BELMONT MIDDLE AND HIGH SCHOOL BUILDING COMMITTEE

AUGUST 28 2019

VE STRATEGIES - EXTERIOR

ITEM 04 : SIMPLIFY ALL CURTAINWALL AREAS

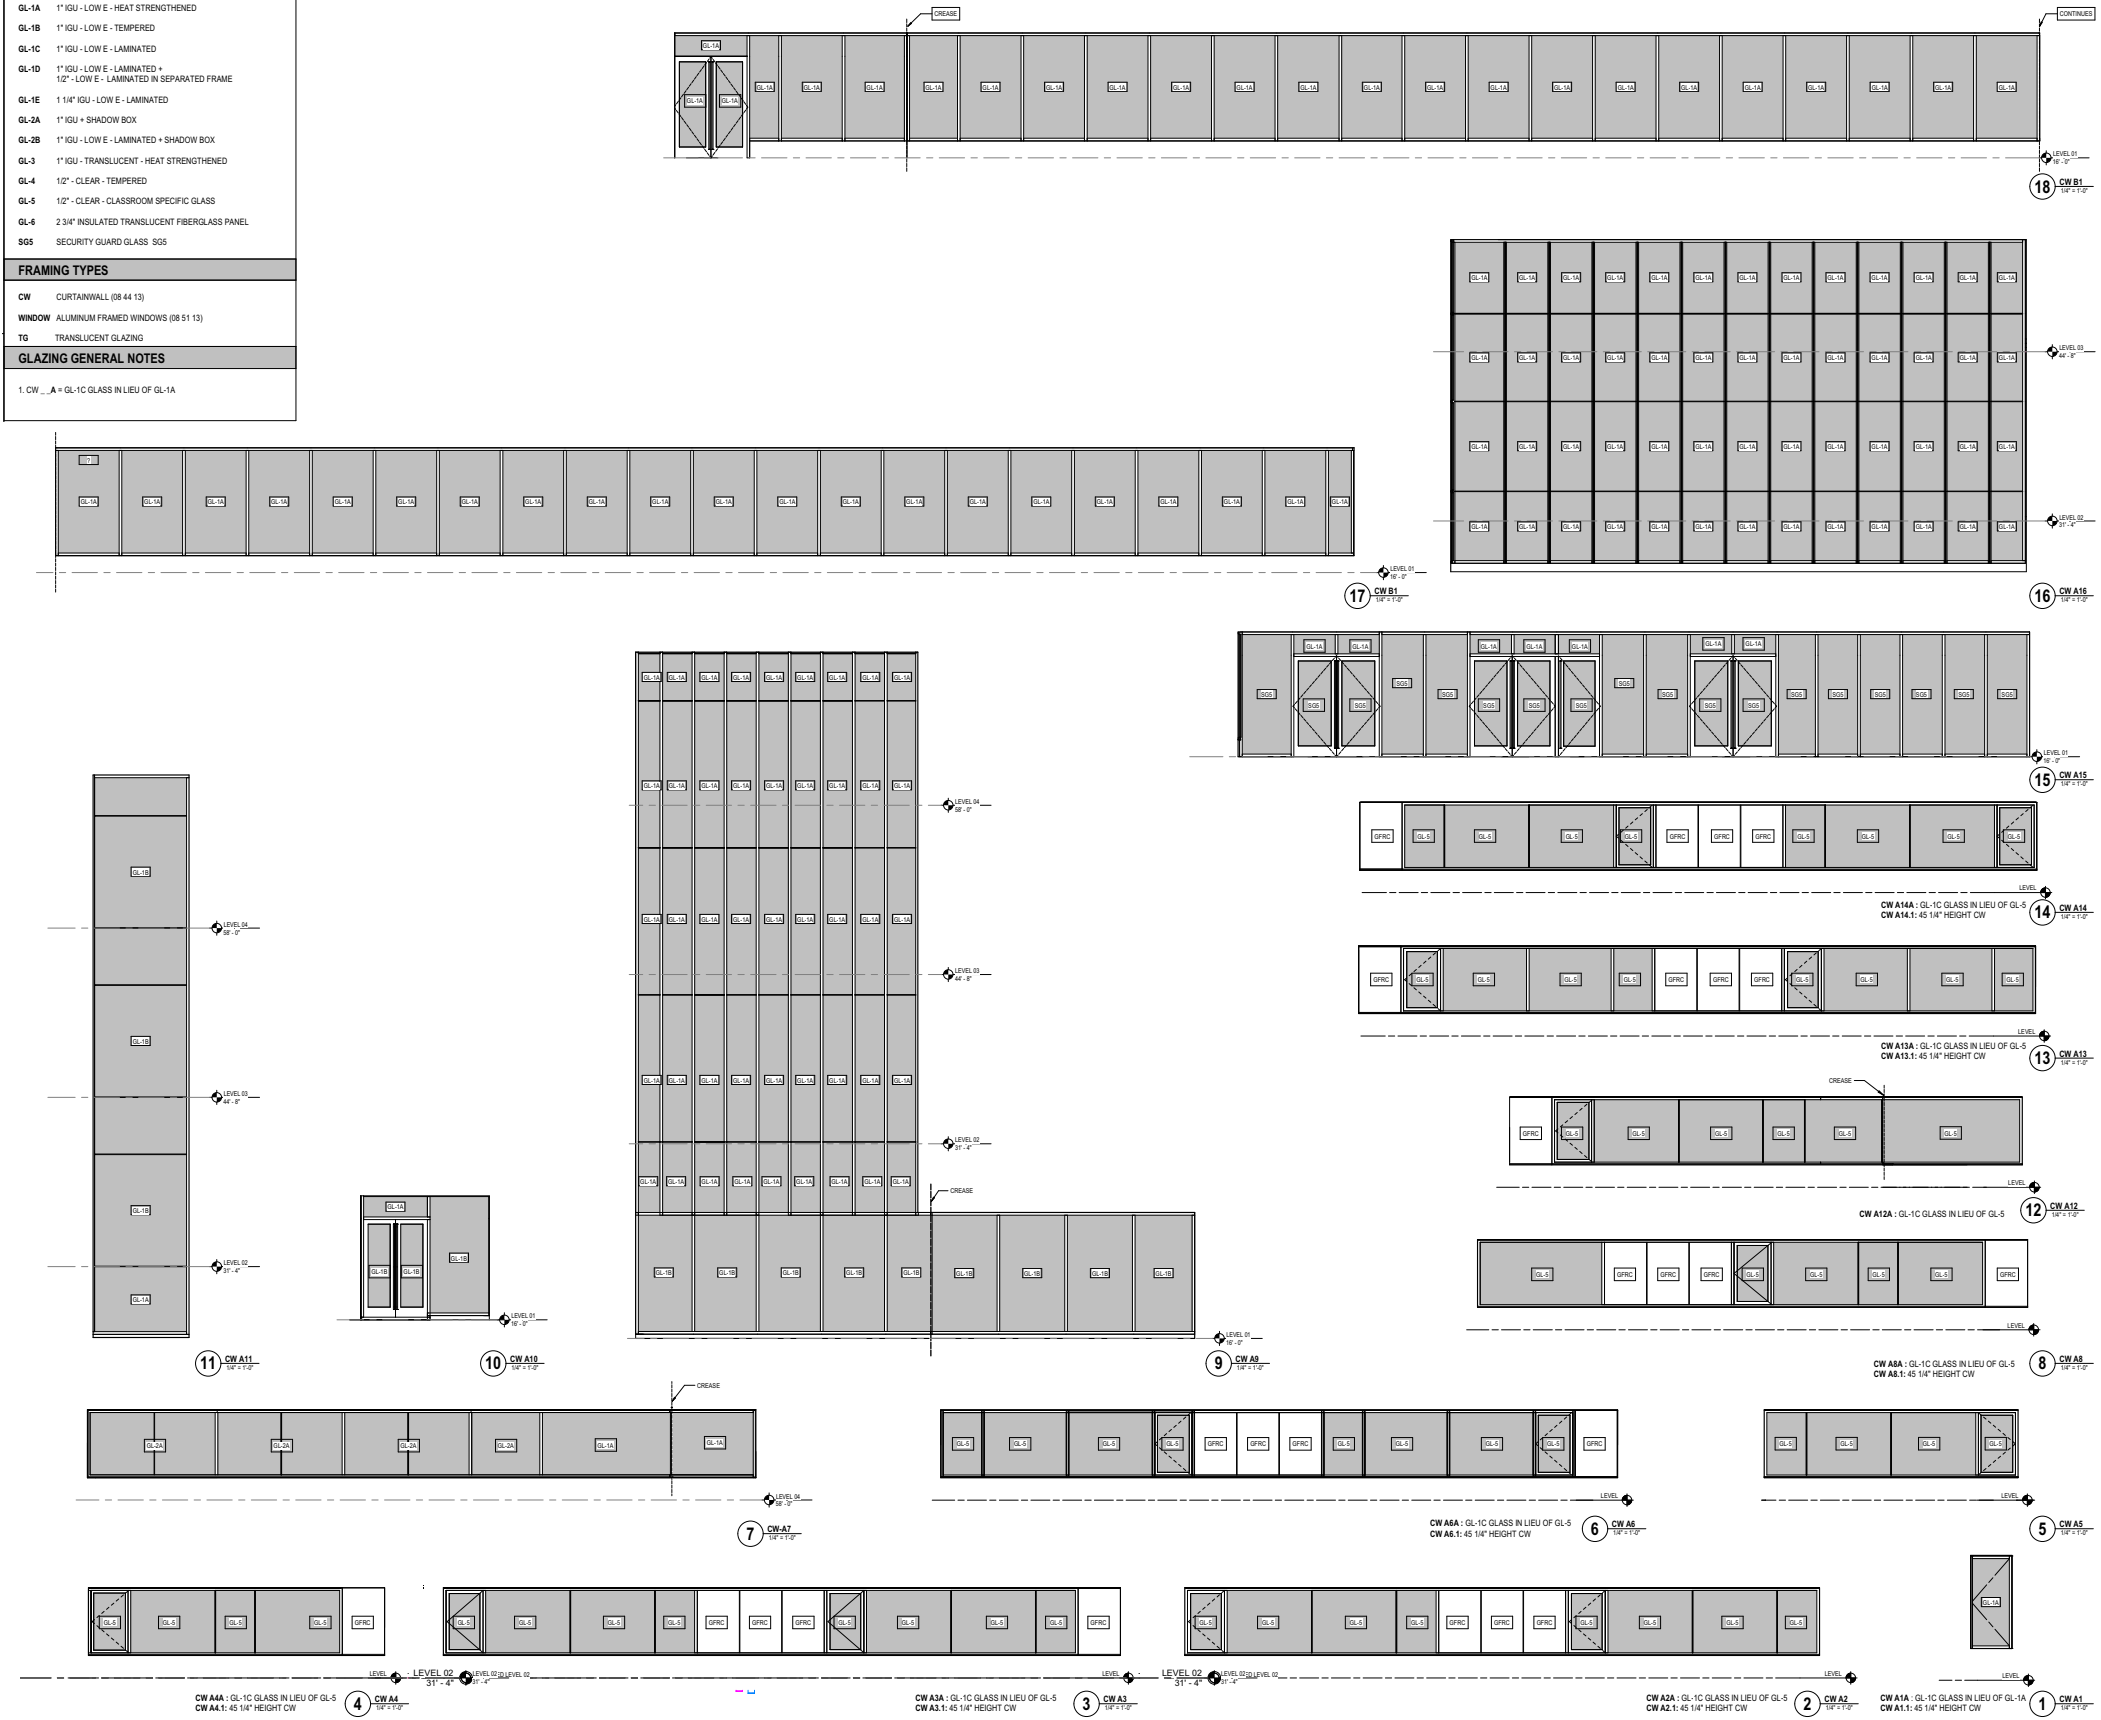
- USING 5'-0" MODULE
- MINIMIZE NUMBER OF LITES

ITEM 05 : REVISE VERTICAL SUNSCREEN CW @ HIGH SHOOL DROP-OFF AREA

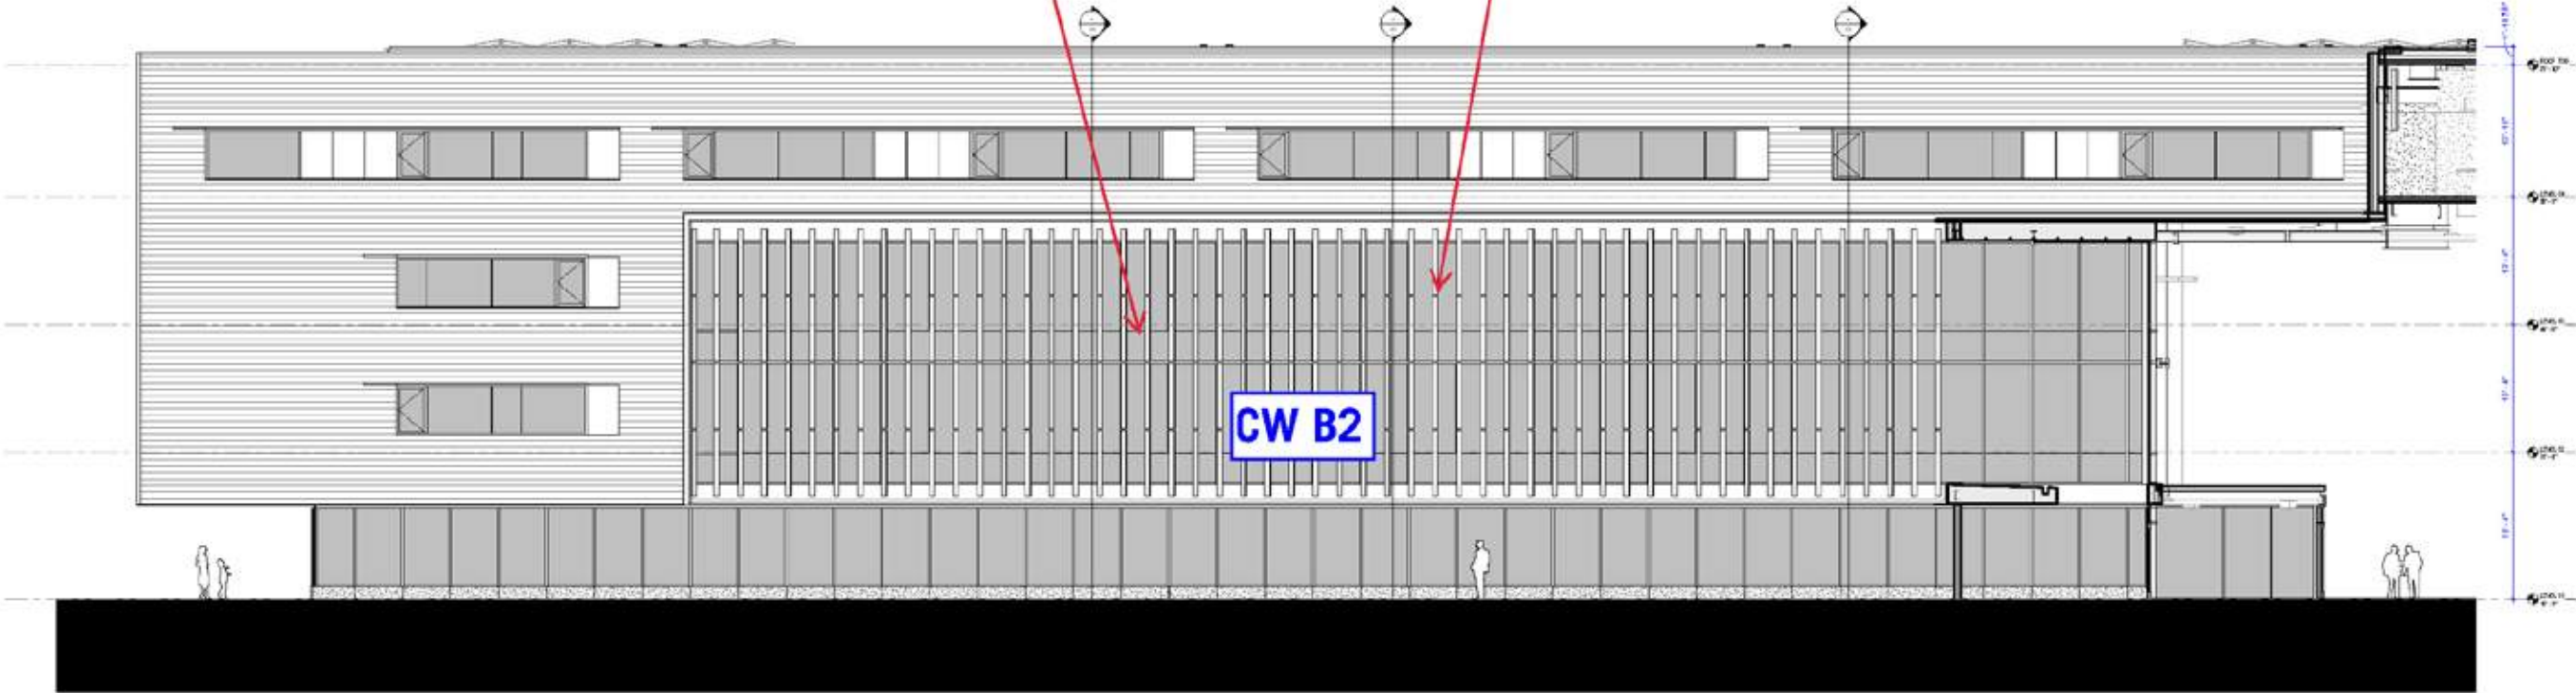
ALL BASELINE HORIZONTAL MULLIONS GO FROM SSG TO EXPOSED CAP ON CW B2.

REDUCE NUMBER OF VERTICAL SUNSCREEN PANELS FROM 6 TO 4 PER COLUMN. ALL PANELS ARE UNIFORM HEIGHT OF 6'-10" PER PANEL (VERIFY MAX HEIGHT). TOTAL CW HEIGHT @ 25'-6"

REDUCES SUNSHADE PANEL COUNT BY 106

ITEM 06 : REMOVE ALL HORIZONTAL SUNSCREENS EXCEPT FOR SOUTH FACING

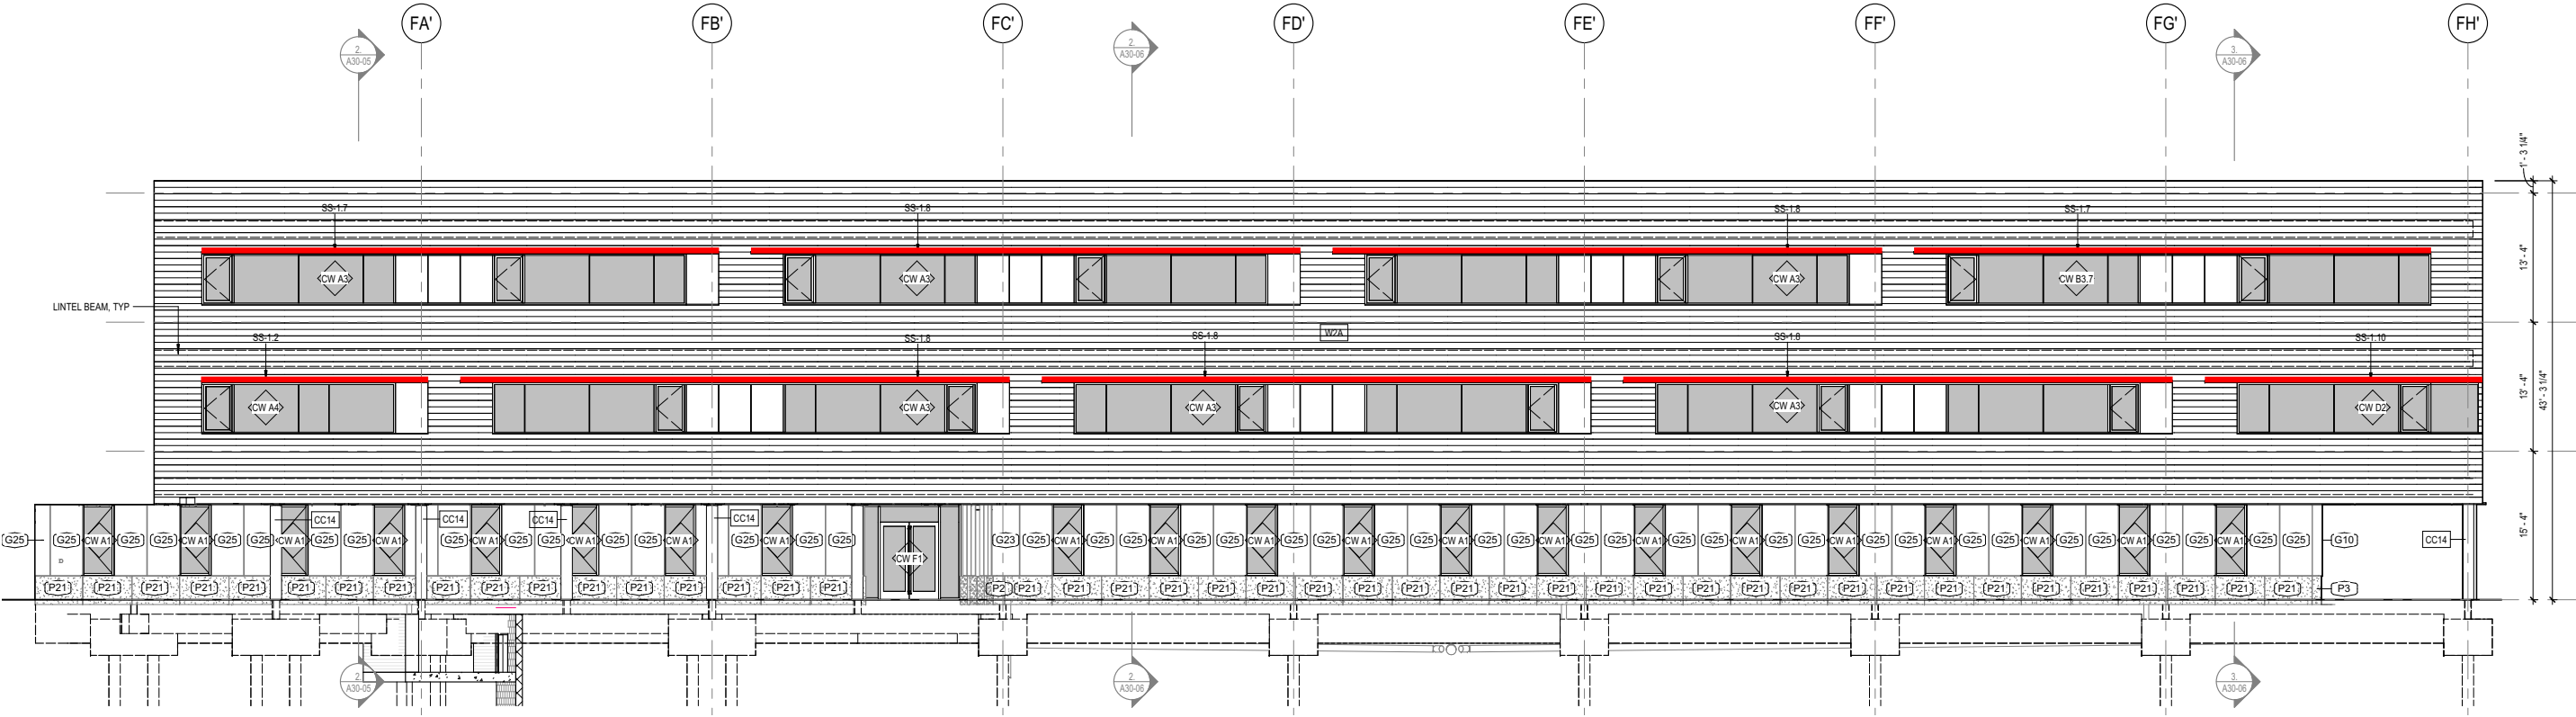
HORIZONTAL SUNSCREEN LINEAR SQ.FT REMOVED: 442' LINEAR FEET

ITEM 09 : REDUCE FIRST FLOOR WINDOWS AT MUSIC / BAND FACADE (AREA B)

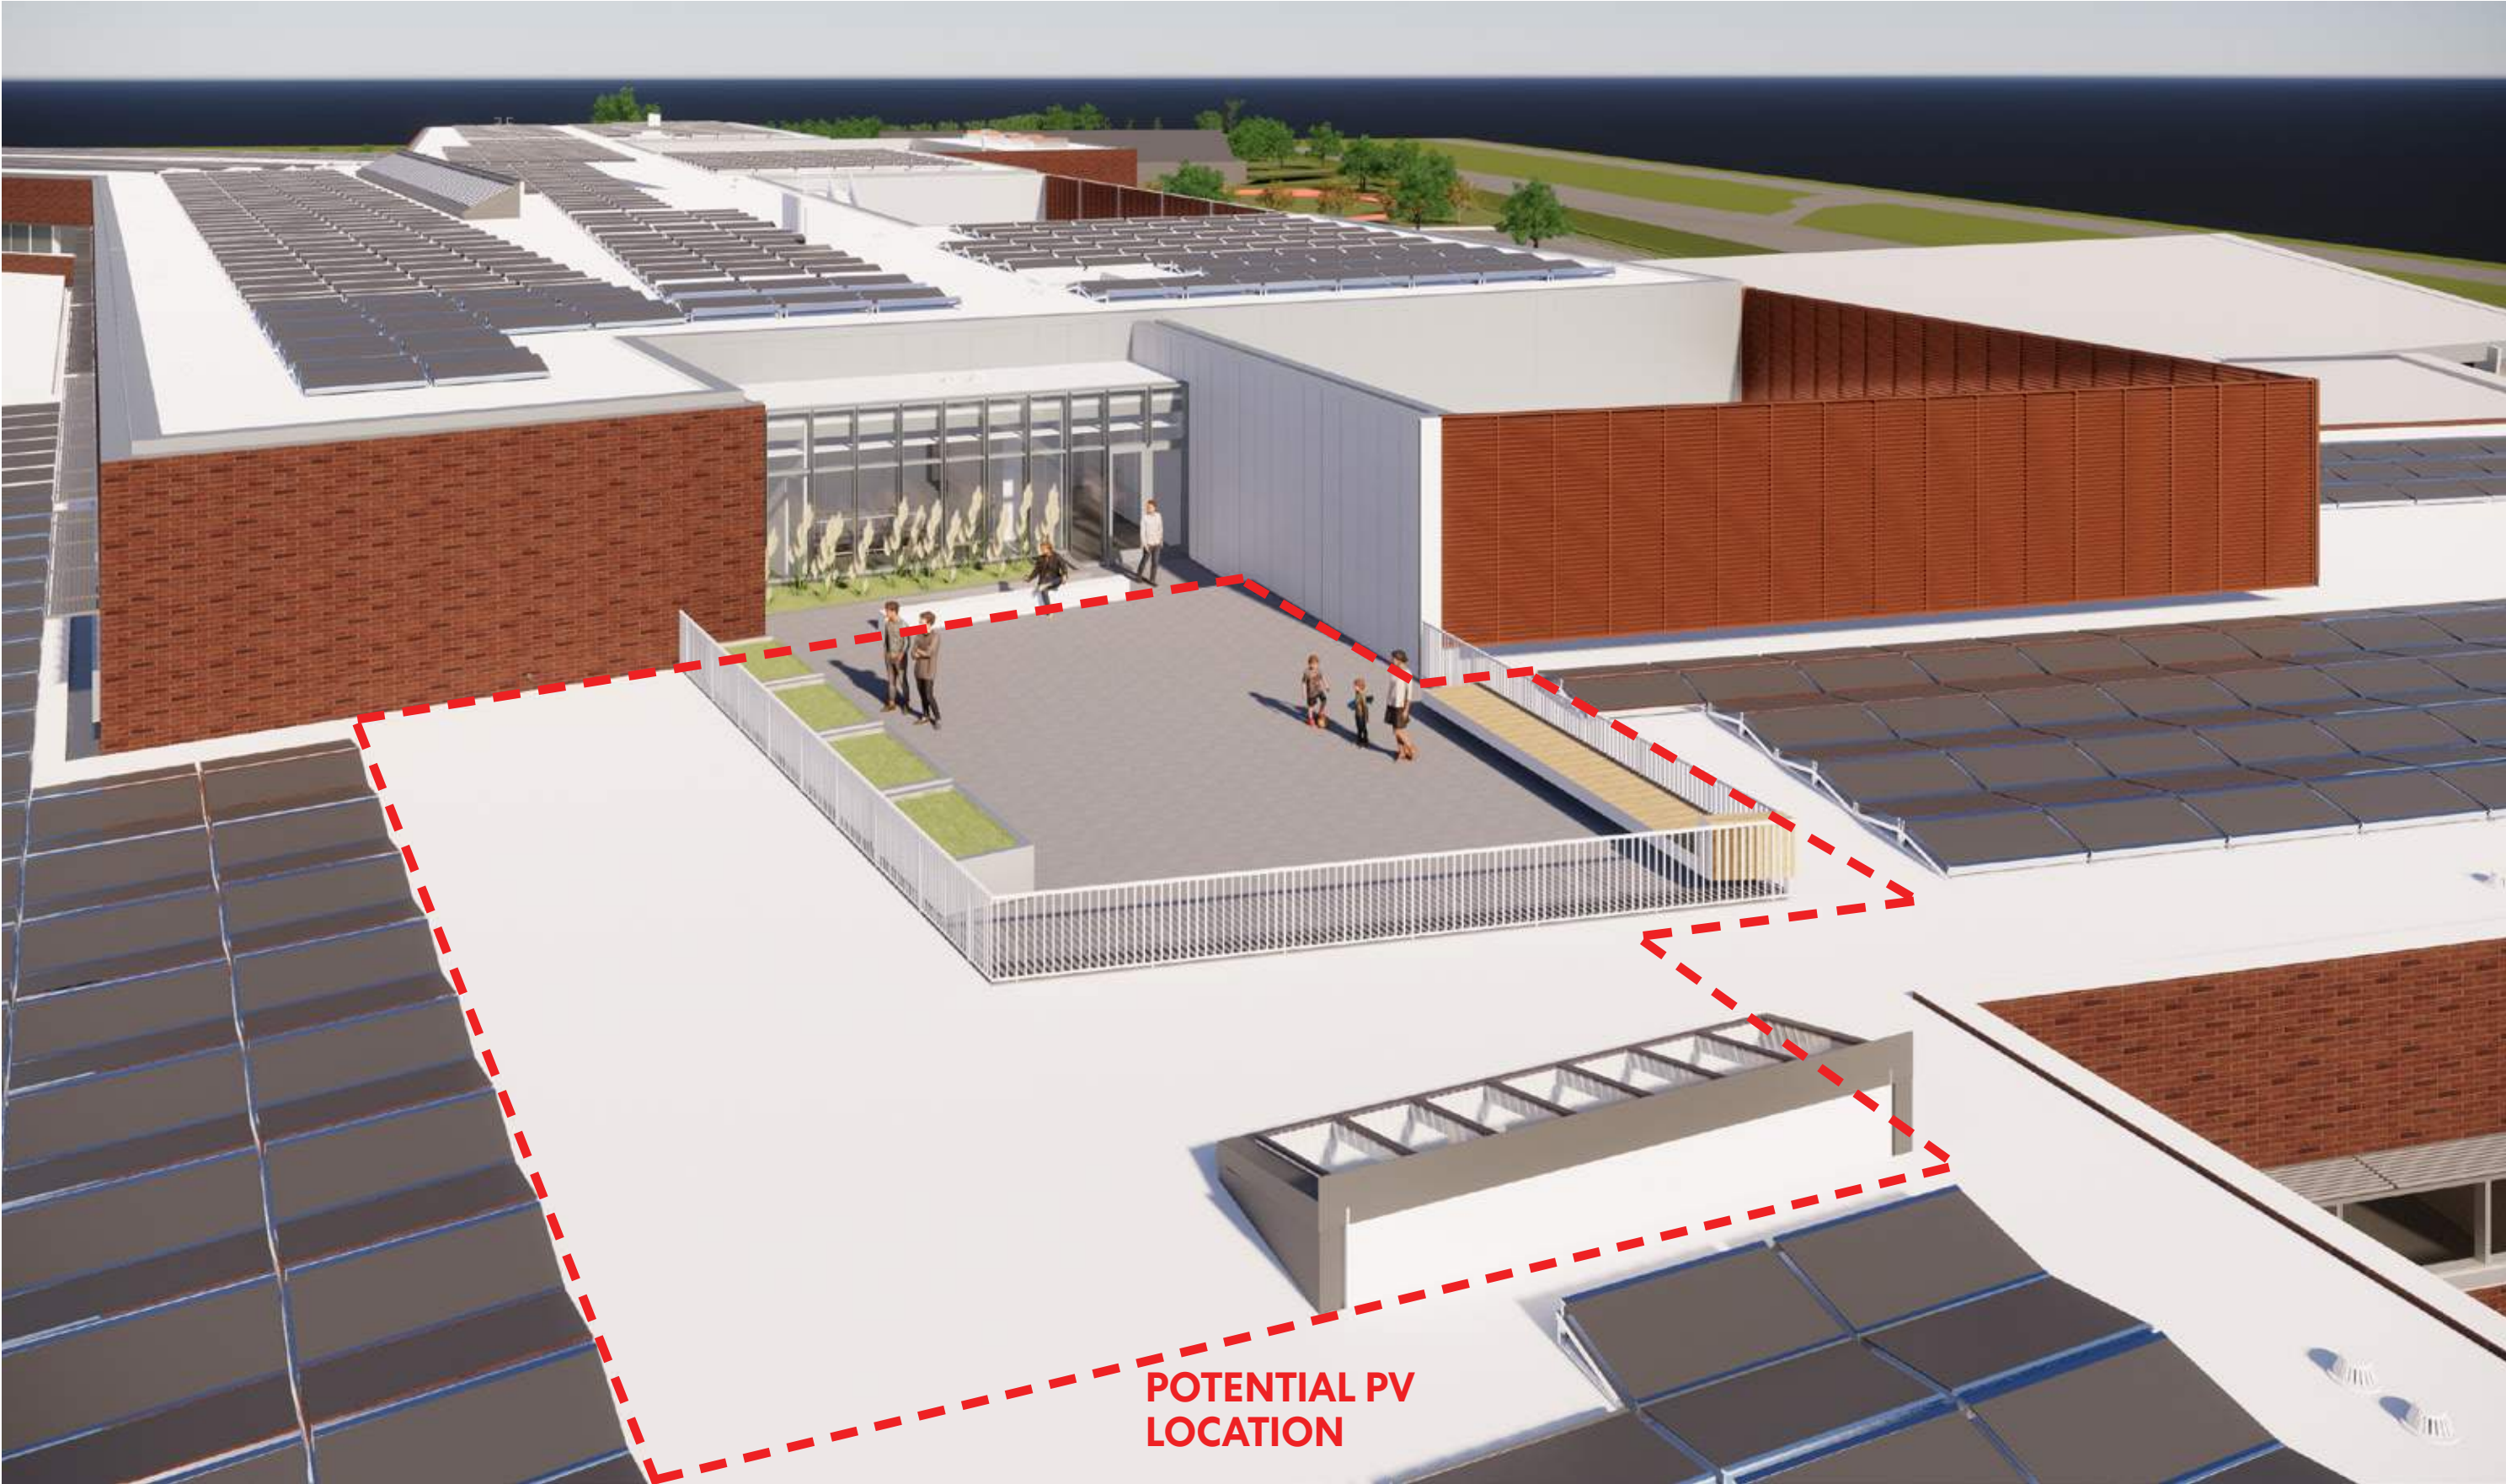
MASONRY IN LIEU OF CURTAIN WALL
